Design and construction of deep water quays at Dar es Salaam and Mombasa

DISCUSSION

Fig. 11. Quay designs

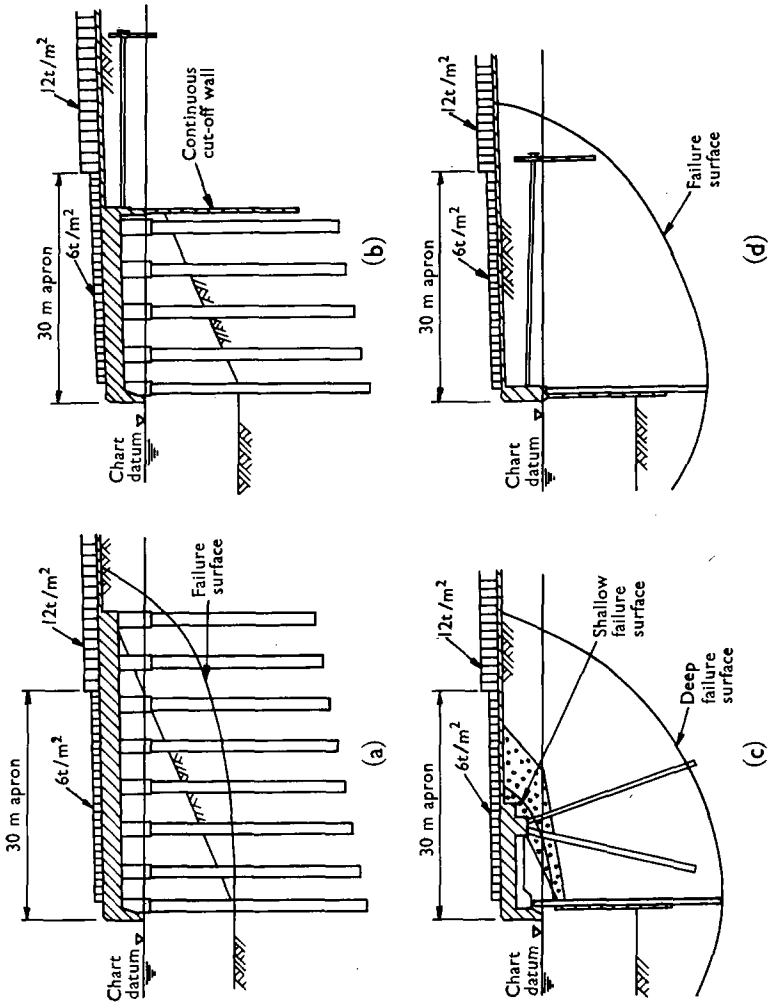
80. There may be occasions when, due to a hold-up in shipping, copper has to be stacked near the quay apron. In the project design for the proposed berths 12 and 13 recently completed for the Tanzania Harbours Authority, it was assumed that loadings of 6 t/m² might in an emergency, be applied to the quay apron. Heavier loadings of up to 12 t/m² were assumed possible for the areas behind the apron. These loadings influence the choice of type of quay structure. Fig. 11 shows the types of quay structure which were considered. Type (a), which is similar to that described by the Author, requires a very wide deck in order to avoid the risk of slip failure in the bank underneath. The potential failure plane is indicated.

81. One solution to this problem, shown in Fig. 11(b), is to provide a continuous rear cut-off wall to intercept the failure plane. However this involves the use of sheet piling which has to be tied back to resist permanent lateral earth pressures.

element. Fig. 11(c) shows a relieving platform type which has been used extensively in Holland. Cost comparison with the simple tied sheet pile design shown in Fig. 11(d) showed that in Dar es Salaam conditions the relieving platform scheme would not be the cheapest design.

Fig. 12. Layout of berths: Mombasa

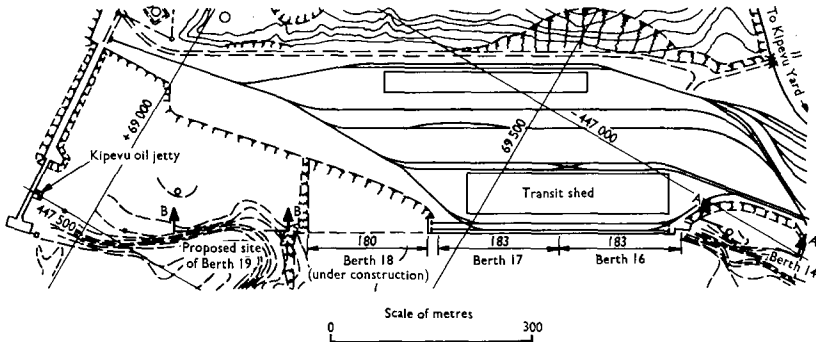
I wish to confine my remarks to soil conditions on the Mombasa project. Bertlin and Partners are in a somewhat special position at Mombasa in that we are currently studying port developments on both sides of berths 16 and 17. One development is at berth 15 which was previously avoided because of the relatively poor soil conditions. The other is at berth 19 where conditions are similar to berth 15 (Fig. 12).

Fig. 13. Geological section : proposed berth 15

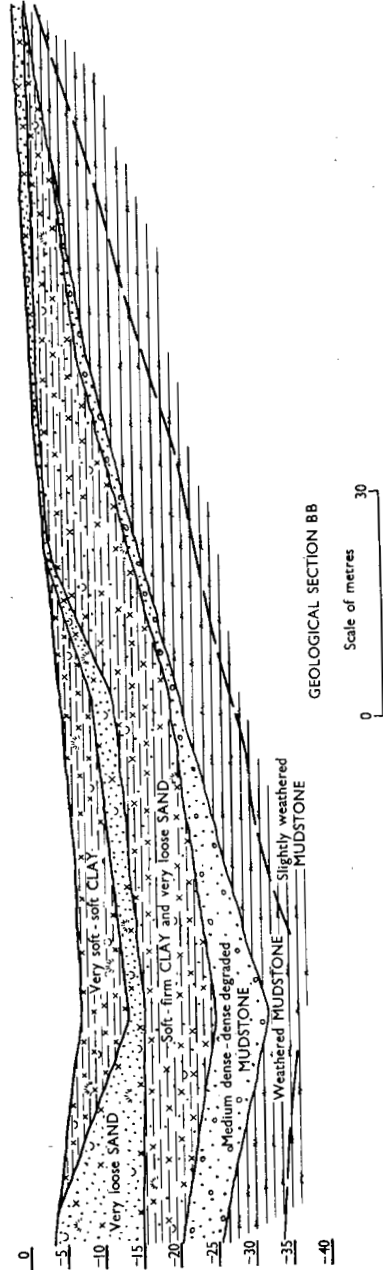
84. Figure 13 shows the geological formation at berth 15. The bedrock is mudstone (in the Paper this is described as shale and use of the term 'mudstone' is only a marginal preference) with a highly weathered layer above it. The surface layer represents the lowest point of erosion of the original formation. At Mombasa, as at Dar es Salaam, there have been rises and falls in the sea level over a period of geological time which have caused successive erosion and infilling. The layer immediately overlying the weathered mudstone we have described as 'degraded mudstone'. This material is very similar in appearance to the highly weathered mudstone but the presence of foreign matter suggests that it has been transported and not weathered in situ. Because of this its properties can be expected to differ and it will probably be weaker.

85. There is more material described as 'degraded mudstone' at a higher level. This exhibits rounded fragments of mudstone, unlike the lower formation which has angular fragments. The former suggests water transportation and the latter movement due to slips. There is a similar pattern at berth 19 (Fig. 14) although only one layer of 'degraded mudstone' is present.

86. In the Paper the Author does not show the relationship of the quay structure to the soil strata on which it is founded. However, in § 51, he noted that a problem had been encountered with the rubble bank. It would be of interest to know on what stratum this bank has been founded, particularly in the light of soil conditions identified at adjacent berths.

Mr Butcher asks for information regarding the stratum on which the rubble retaining bank at Mombasa is built. In berth 16 and the east and west ends of berth 17 the bank is founded on hard shale. For the remaining part of berth 17 the bank is founded on the sand deposited as shown in Fig. 9. It appears, however, from subsequent investigations that a layer of clay of varying quality was left under the bank or was the result of deterioration of the shale which had been exposed during dredging. This material has probably allowed for settlement into it of the rubble and reclamation filling and although slip circle analyses have been carried out, in answer to **Mr Hunter**, it is not thought that such failure is the principal reason for movement in the piles.
